# Service Bulletin

No 14 rev 3 2008-04-08

## Non return valves for protection of air distributor CD Units.

4mm non return valve  
47206

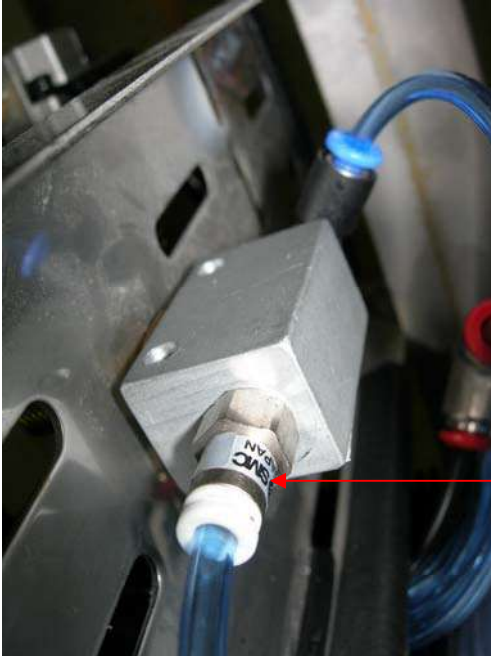
We have experienced damaged to the air distributor in the electric cabinet caused by water penetration on some vessels. This has been caused by leakage of the non return valve #137 on the circulation tank #52. See picture below:

In order to avoid and correct this problem Marinfloc recommend that the non-return valve is checked for leakage and replaced if necessary. Marinfloc also recommend that an extra non return valve is added to the hose after the air adjustment valve #136 for extra safety. See picture below:

Non return valve ¼" #137 article number: 16101

Non return valve 4mm for hose article number: 47206

If you have a CD unit which is not equipped with this 4mm non return valve for hose or with thread see picture below Marinfloc AB will supply one free of charge ex. Works, Varekil Sweden
